IEE802.3 4P Task Force

Figure 33A-1- Rpair_max_PD and Rpair_min_PD PD common mode input effective impedance

November 2015

Comment [Annex 33A.5 Page 172 line 31]

Figure 33A-1- Example for PD common mode effective impedance calculation

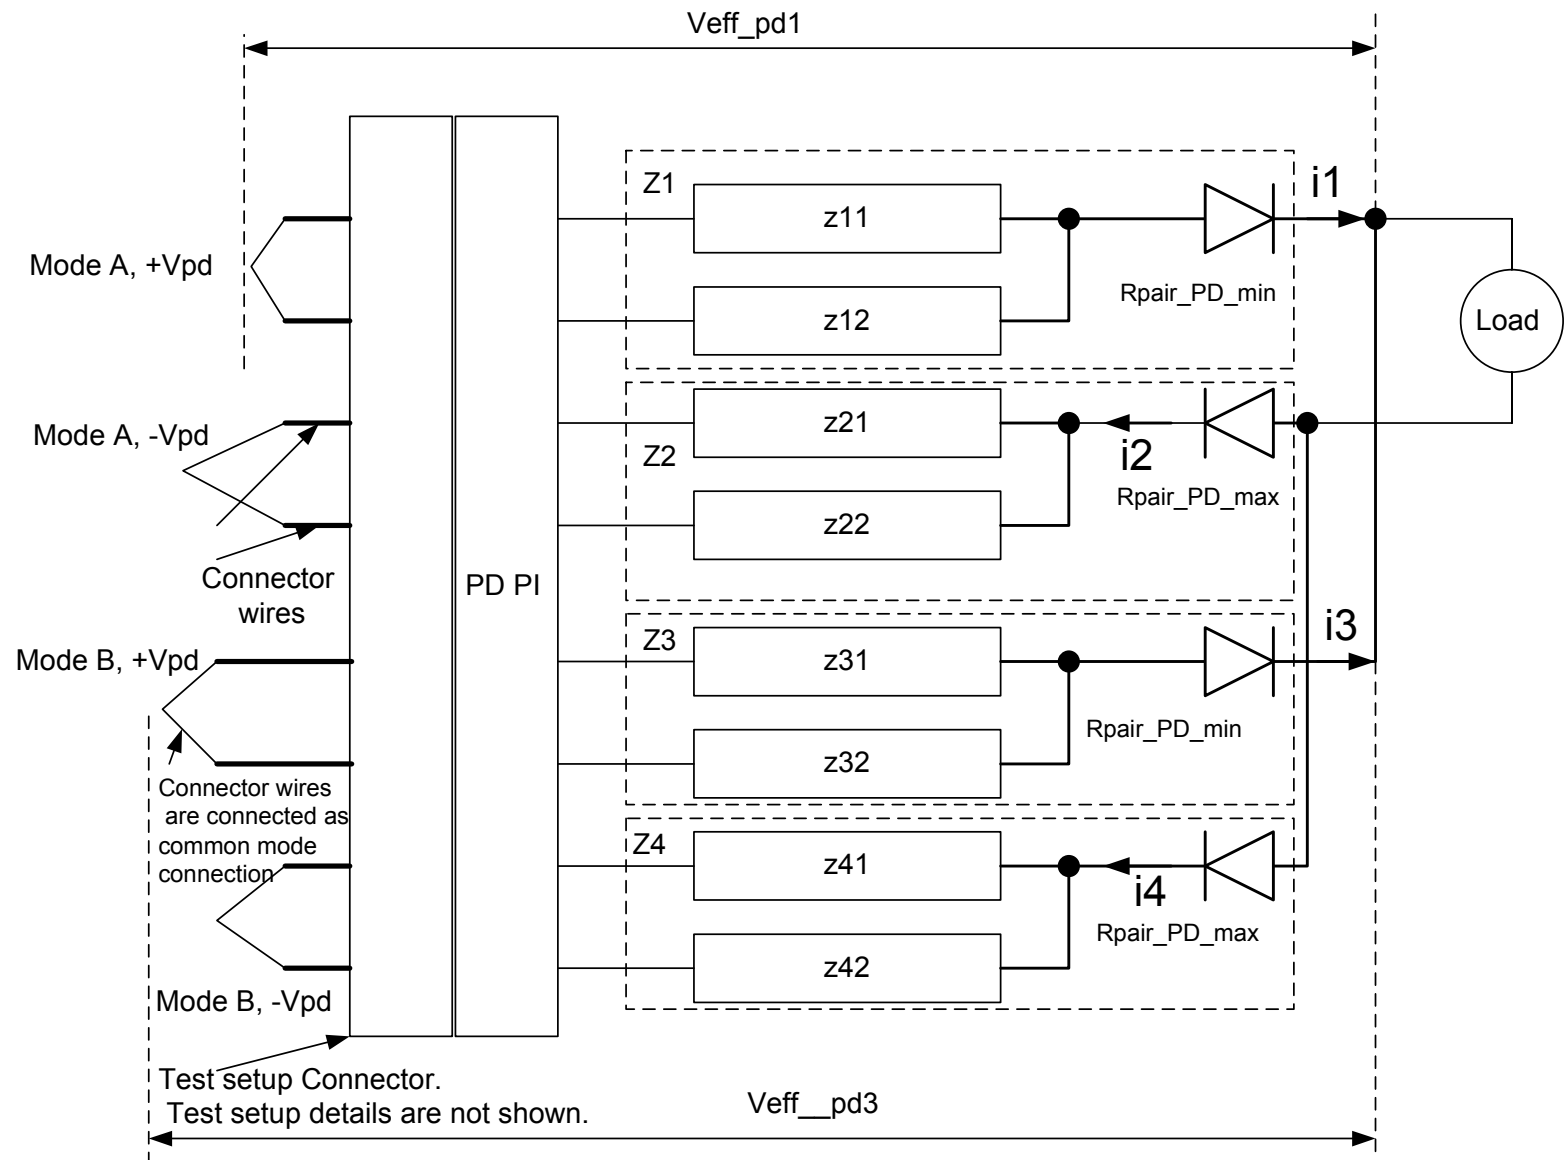
1. Add the following text after line 31

RPair_PD_max and RPair_PD_min represent PD common mode input effective impedance of pairs of the same polarity.

The effective resistance Z_i is the measured voltage $V_{eff_pd_i}$, divided by the current through the path as described below and as shown in the example in Figure 33A-1.

2. Add figure 33A-1 after the above text as described in page 3 of darshan_01_1115.pdf3.

Positive pairs:

$$Z1 = RPair_PD_min = V_{eff_pd1} / i1$$

$$Z3 = RPair_PD_max = V_{eff_pd3} / i3$$

Negative pairs:

$$Z2 = RPair_PD_min = V_{eff_pd2} / i2$$

$$Z4 = RPair_PD_max = V_{eff_pd4} / i4$$
